**ADDENDUM NO. 06**  
February 09, 2010

Project: **Package C – 2009: Holbrook Elementary School Renovations**  
Cypress-Fairbanks Independent School District

Bay Project No.: 0840 (10-01-2069R-FP)

ADDENDUM#  
6-SKT-7

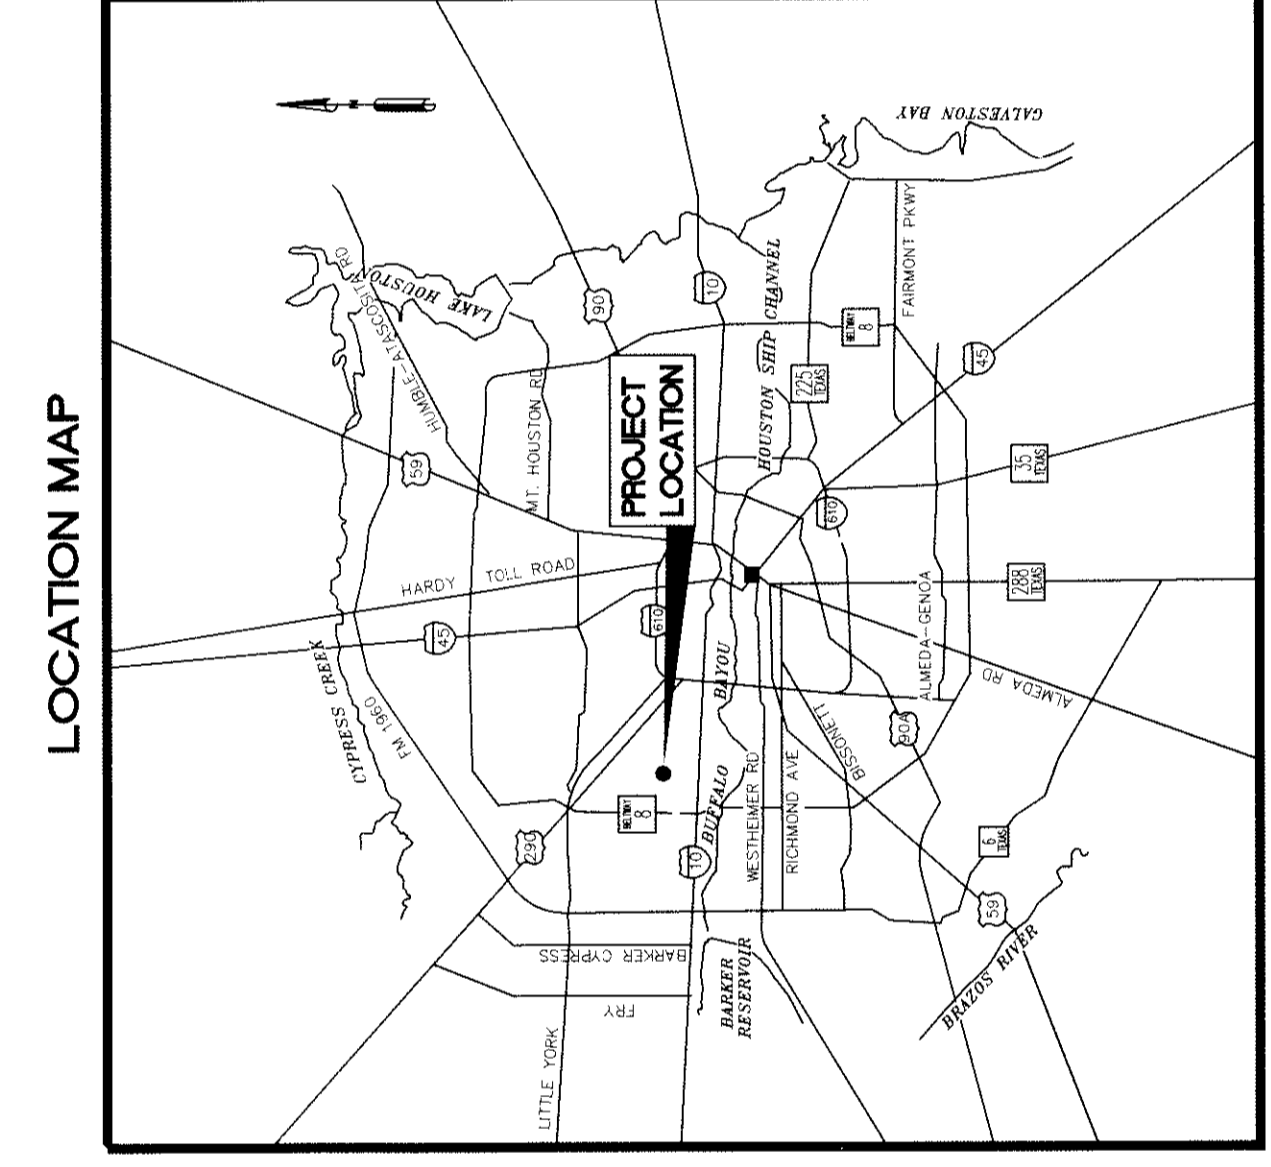
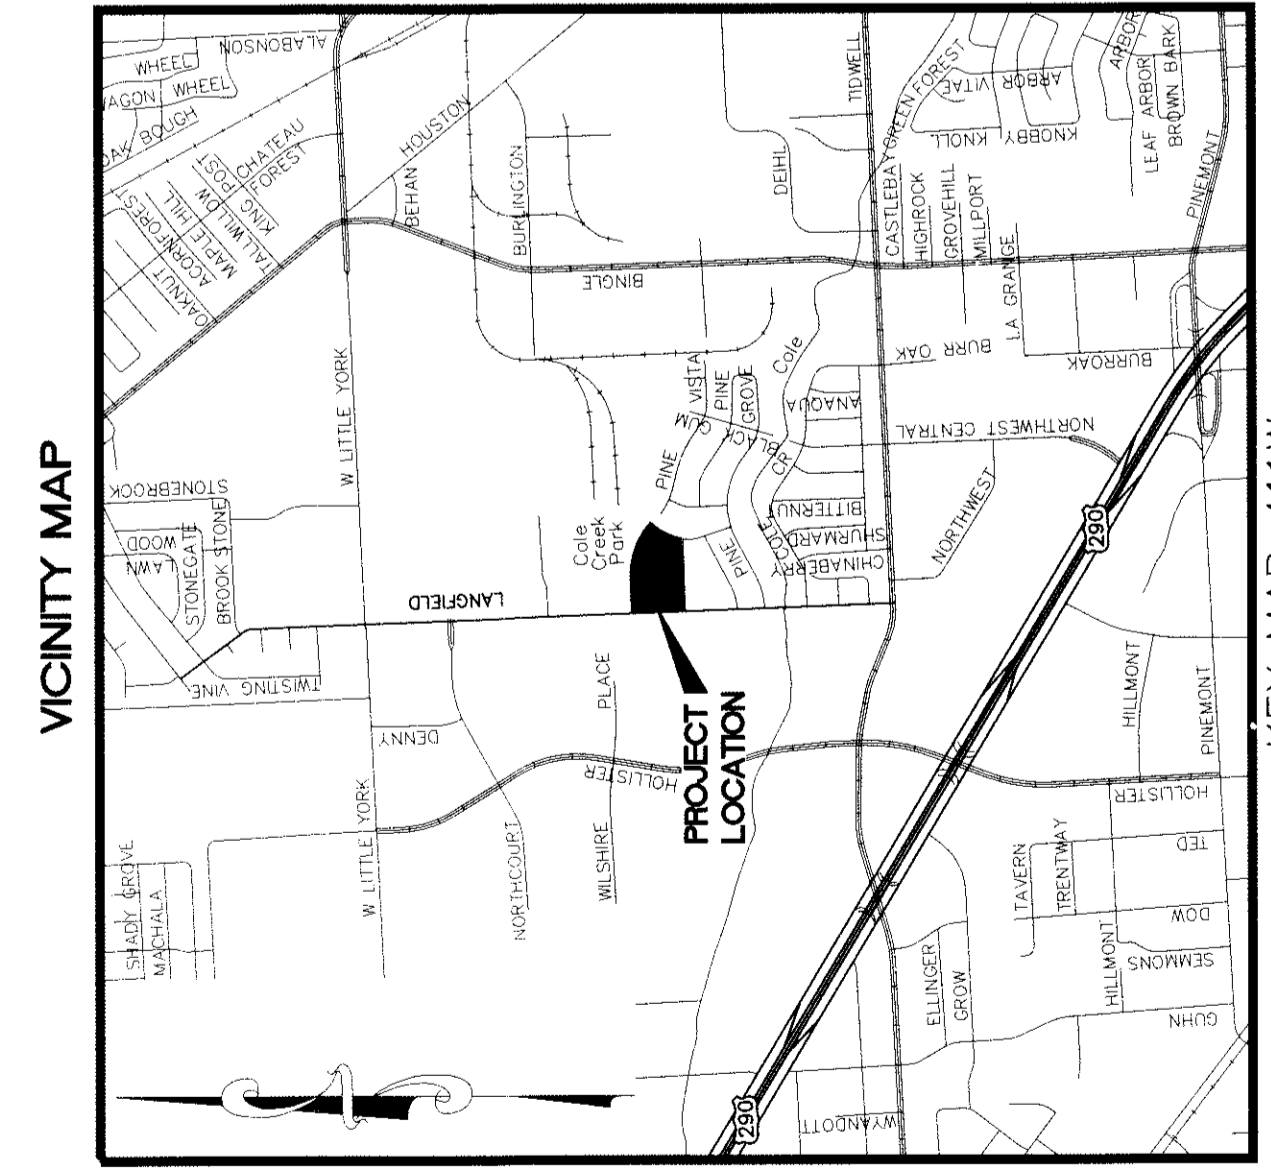
- b. Added reference note for proposed sanitary sewer plan and profile work in Langfield right-of-way as indicated on attached sketch ADD-6-SKT-7.
